Revisions			
P01 24.08.16	Planning	ML	PY
P02 27.04.17	Planning	ML	LP

PLANNING

Project
TWICKENHAM STADIUM
EAST STAND EXTENSION

Drawing title
EXTERNAL WORKS - ZONE 4
LANDSCAPING / TURNSTILE SETTING
OUT PLANS

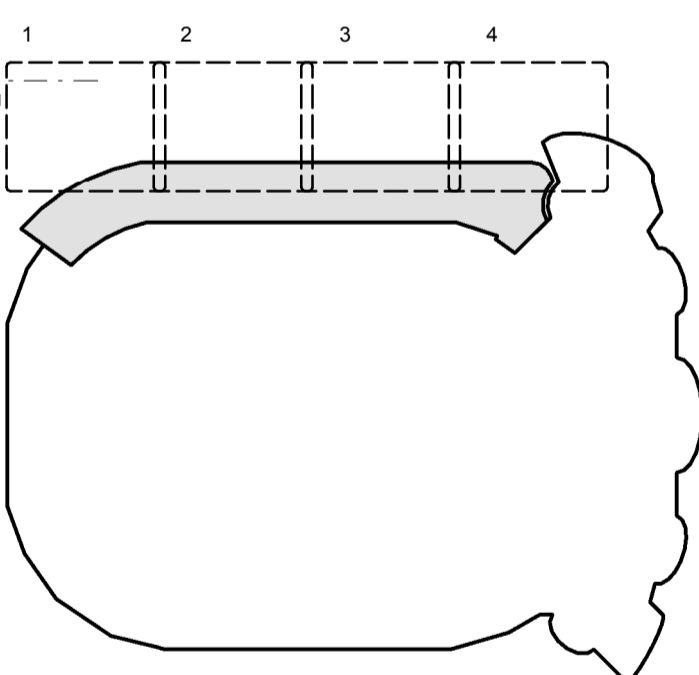
- A GENERAL AMENDMENTS TO THE SOUTH END.
- A1 INCREASED SHINGLES CLADDING AREA AND CURTAIN WALL REDUCED ACCORDINGLY.
- A2 REDUCED MASSING AND REVISED INTERFACE WITH THE SOUTH STAND.

- B PPC LOUVRES LOCATED TO THE BOWL SIDE HAVE BEEN OMITTED.
- C CURTAIN WALL SETTING OUT REVISED GENERALLY. SILICON JOINTS TO TRANSOMS AND MULLION REPLACED WITH CAPPED SYSTEM. LEVEL 04 PPC LOUVRES SETTING OUT & HEIGHT REVISED. MONORAIL FOR ABSEILING REMOVED.

- D GENERAL AMENDMENTS TO THE CENTRAL ELEVATION CANOPY AT LEVEL 5A REVISED GENERALLY AND STANDING SEAM REPLACED WITH SINGLE PLY MEMBRANE. SUPPORT COLUMNS TO ROOF CANOPY REVISED. SQUARE FASCIA TO ROOF EDGE.

- D1 LEVEL 5A GLAZED SCREEN EXTENDED IN HEIGHT AND PPC LOUVRES INCLUDED AT LOW LEVEL.
- D2 INCREASED SHINGLES CLADDING AREA AND CURTAIN WALL AREA REDUCED ACCORDINGLY. FOUR VERTICAL FINES REMOVED.

- D3 PORCELAIN PANELS WITH SLOTTED HOLES FOR VENTILATION REPLACED WITH PPC LOUVRES. EXPRESSED HORIZONTAL PATTERN TO PORCELAIN PANELS OMITTED.
- E GENERAL AMENDMENTS TO THE NORTH END

- E1 PORCELAIN CLADDING REPLACED WITH PPC ALUMINIUM CLADDING.
- E2 GREEN WALL TO THE NORTH END EXTENDED AND PPC LOUVRES REMOVED.
- E3 INCREASED SHINGLES CLADDING AREA AND CURTAIN WALL REDUCED ACCORDINGLY.

- F FENCELINE, GATE AND PERIMETER COLUMNS SETTING OUT REVISED.
- F1 CANOPY TO TURNSTILES REVISED.
- G PORCELAIN PATTERN CHANGED FROM HORIZONTAL TO VERTICAL.

- H PORCELAIN PANELS TO THE SOFFIT OF THE ARCH REPLACED WITH PPC ALUMINIUM PANELS. PORCELAIN PANELS SETTING OUT REVISED.
- K ROOF TO LEVEL 5A (NORTH END) EXTENDED.

- L GLAZED SPANDREL PANELS REPLACED WITH METAL SPANDREL PANEL. PORCELAIN PANELS REPLACED WITH PPC ALUMINIUM CLADDING.
- L1 PPC LOUVRES INCLUDED FOR MECHANICAL VENTILATION.
